Docket Number:	97-AFC-01C
Project Title:	High Desert Power Plant
TN #:	215765
Document Title:	GSI Water Solutions, Inc. Technical Review of CDFW Water Balance Study
Description:	N/A
Filer:	Eric Janssen
Organization:	Ellison, Schneider & Harris L.L.P.
Submitter Role:	Applicant Representative
Submission Date:	2/3/2017 5:03:07 PM
Docketed Date:	2/6/2017

Re: High Desert Power Plant Project (97-AFC-01C)
GSI Water Solutions, Inc. Technical Review of the California Department of Fish and Wildlife
“Water Balance Study for the Transition Zone of the Mojave River” (TN#: 214837)

Technical Memorandum

Re: **Technical Review of California Department of Fish and Wildlife
Water Balance Study for the Transition Zone of the Mojave River Basin
(TN #: 214837)**

Figure 1. Annual Groundwater Level Change versus Annual Water Budget Residual

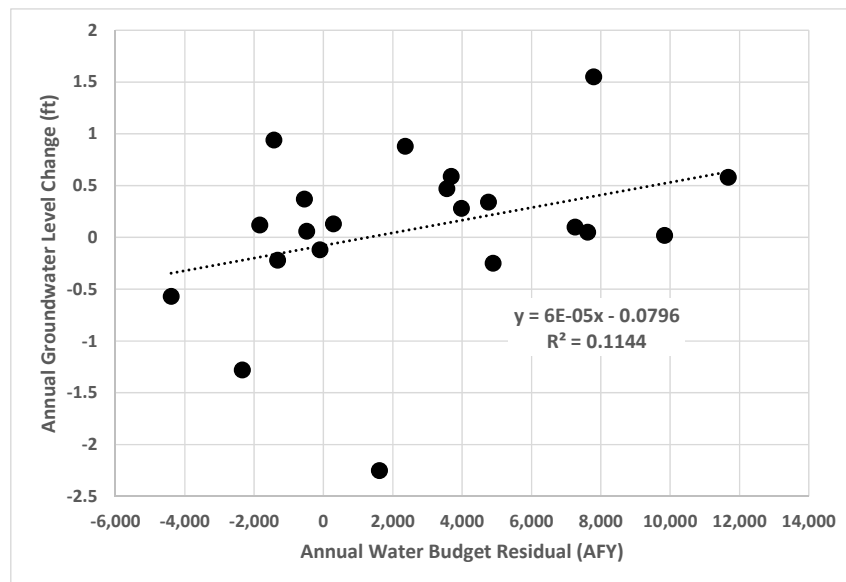
Annual groundwater level changes would be expected to be correlated with the water budget residuals, not the annual change in water budget residual. GSI explored the relationship between annual water level groundwater level changes and water budget residuals using the raw data from the Water Balance Study, as shown in Figure 1 below.

The exceedingly poor correlation (R^2 of 0.11) between the annual groundwater level change and annual water budget residual is quite evident in Figure 1. For example, there are a number of years in which groundwater level rises are associated with negative water balance residuals and vice versa, as well as a number of years with large positive residuals that are associated with near zero groundwater level changes. These relationships are completely contrary to what is expected and is further evidence that the water balance method as applied in the CDFW report is seriously flawed.

Figure 2. Double Mass Balance Curve Using Raw (non-adjusted) Data

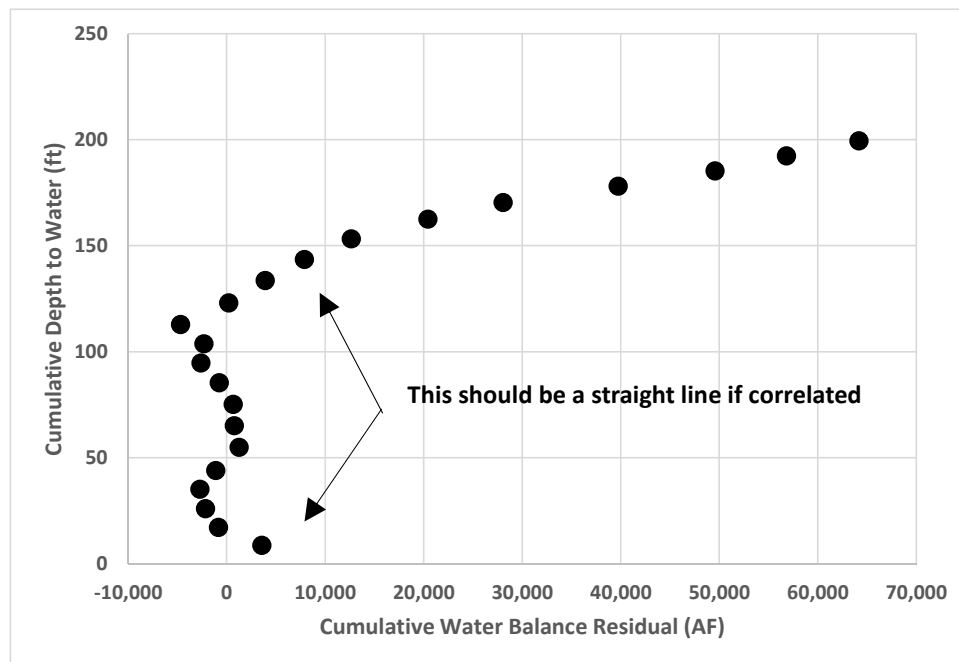
2. The double mass curves are meaningless because a large constant value was added to each water balance residual prior to calculating the cumulative values. The addition of a large constant value to the water balance residual creates an artificial, meaningless relationship with groundwater level changes. It appears the CDFW found it necessary to adjust the data because the raw data do not show a meaningful relationship, as shown in Figure 2 below.

3. The slope of the double mass curve cannot be used to calculate the mathematical relationship between the parameters being investigated because it is the cumulative values of the terms that are plotted on the double mass curve. Thus, even if the water balance residuals were valid, not adjusted, and well correlated with groundwater level changes, calculating the slope of the double mass curve would still be an invalid approach for estimating the groundwater level changes associated with a given water balance residual.

Figure 3. VVWRA Discharge versus Wetted Channel Length

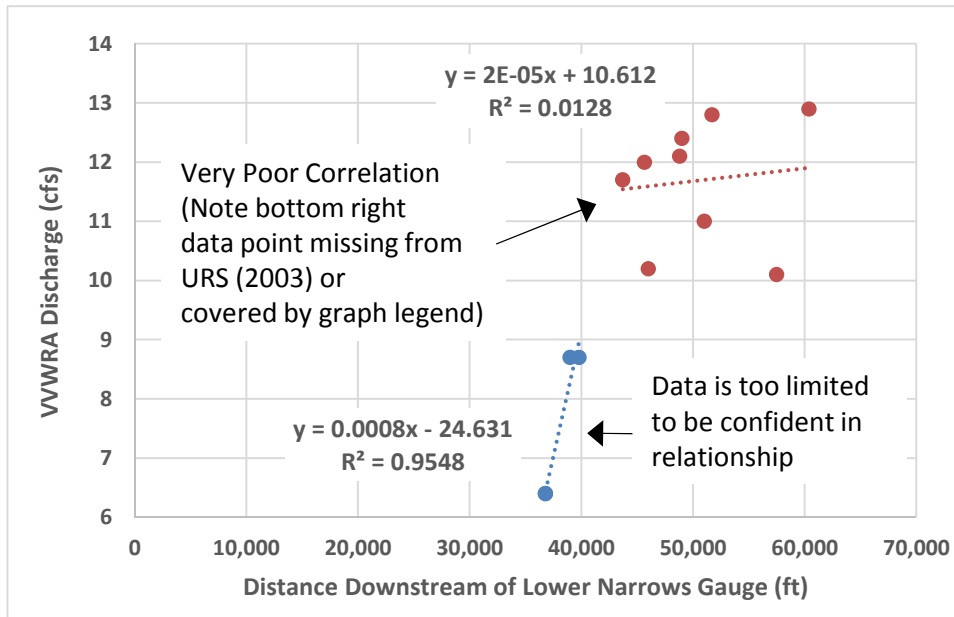
1. The percolation rates developed by URS are based on very limited data in one case and an exceedingly poor correlation in the other, as depicted in Figure 3 below. The likely reason for the poor correlation is the fact that VVWRA discharge is not the sole factor influencing wetted channel length. Other factors include groundwater levels, vegetation density, and antecedent conditions. For example, for a given VVWRA discharge rate, the wetted channel length will

likely be longer following a wet winter than following a dry winter. CDFW made no attempt to account for these important factors.

2. The second flaw in the analysis is the assumption that percolation rates are constant. Because the Mojave River is a braided stream⁴, percolation rates are highly variable depending on the number of active channels and the combined width of all active channels at any given time. Furthermore, the channel morphology changes dramatically after each stormflow event.

Figure 4. Depth to Groundwater Measured in Transition Zone Key Well H-2

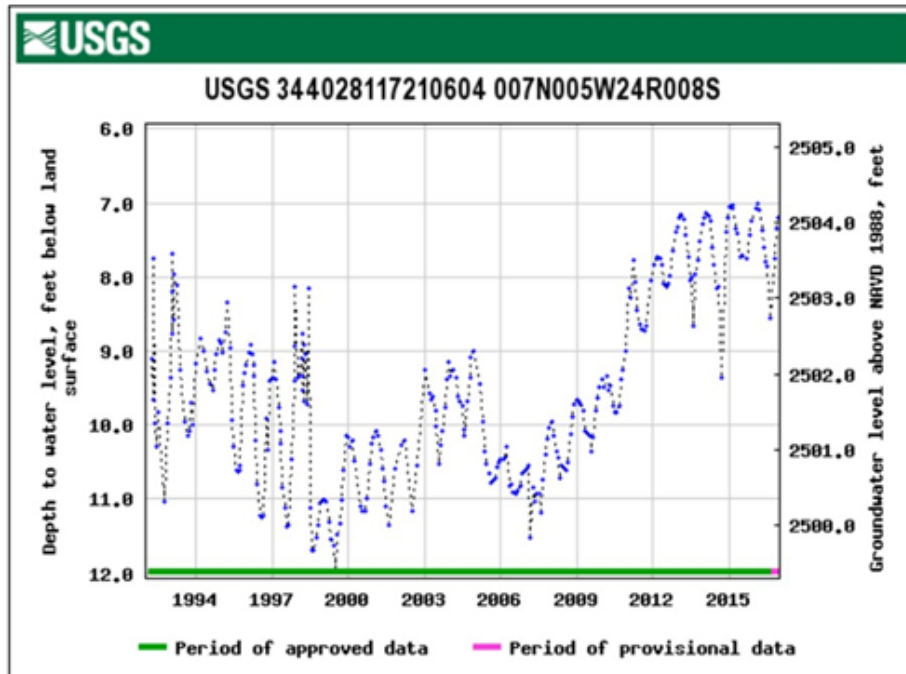
Based on historical data, the first two proposed triggers are unattainable, even with little to no recycled water use by HDPP⁵. Data from the TZ Key Well clearly show that the first two proposed triggers have not been met at any time during the entire twenty-four year period monitoring record of the Key Well, despite very little recycled water use by HDPP during that period.

Moreover, Figure 4 shows that proposed trigger nos. 1 and 2 have not been met for at least twenty-four years, yet the riparian vegetation has nonetheless survived. This suggests that the groundwater level triggers are unnecessarily conservative.
